# Access Compliance Report

## Public Rights-of-Way

### (Curb Ramps)

Intersection ID: 45181	Main Street: SOCIETY_ST	Cross Street: WESTON_GLEN_DR	Location: NW
ADA ID: 7026A79B7024	Ramp Type: PerpDiag	Initial Pass/Fail: Fail	Overall Compliance: No
			Severity Score: 21.25

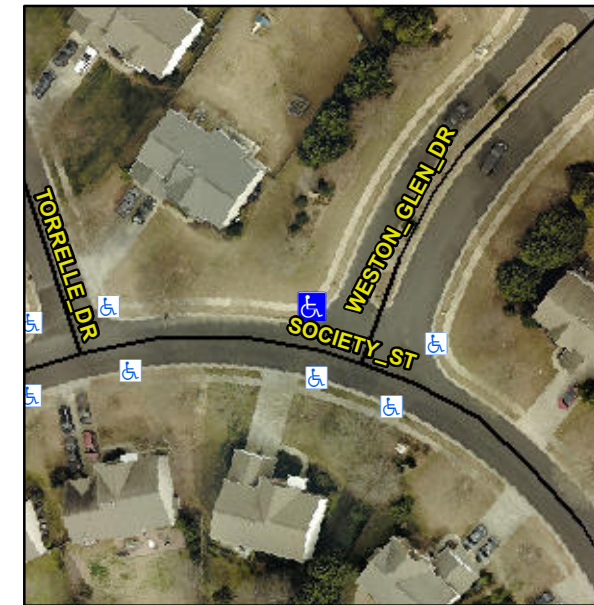
**Not Found, R304.5.1, R304.2.2**

Compliance	Description	Data	Compliance	Description	Data
N/A	Ramp Length (in)	48.5	No	Ramp Slope (%)	9.9
No	Ramp Width (in)	40.0	Yes	Ramp XSlope (%)	1.8
N/A	Flare Type LT	N/A	N/A	Flare Type RT	N/A
N/A	Flare Slope LT (%)	N/A	N/A	Flare Slope RT (%)	N/A
N/A	Flare Traversable LT?	N/A	N/A	Flare Traversable RT?	N/A
N/A	Landing Length (in)	N/A	N/A	DWS Provided?	N/A
N/A	Landing Width (in)	N/A	N/A	DWS Contrast?	N/A
N/A	Landing Slope (%)	N/A	N/A	DWS Length (in)	N/A
N/A	Landing X Slope (%)	N/A	N/A	DWS Full Width?	N/A
N/A	Landing Curb? (Y/N)	N/A	N/A	DWS Offset (in)	N/A
N/A	Shared Landing?	N/A			
N/A	Gutter Ponding?	N/A	N/A	Gutter Slope (%)	N/A
N/A	Gutter Lip Ht (in)	N/A	N/A	Gutter X Slope (%)	N/A
N/A	Painted X Walk1?	No	N/A	Painted X Walk2?	No
	X Walk 1 Direction	To S		X Walk 2 Direction	To SE
N/A	X Walk 1 Width (in)	N/A	N/A	X Walk 2 Width (in)	N/A
	X Walk 1 Slope (%)	2.8		X Walk 2 Slope (%)	4.4
	X Walk 1 X Slope (%)	1.6		X Walk 2 X Slope (%)	0.7

**Remove & Replace Curb Ramp With Two New Directional Ramps or Equivalent.**
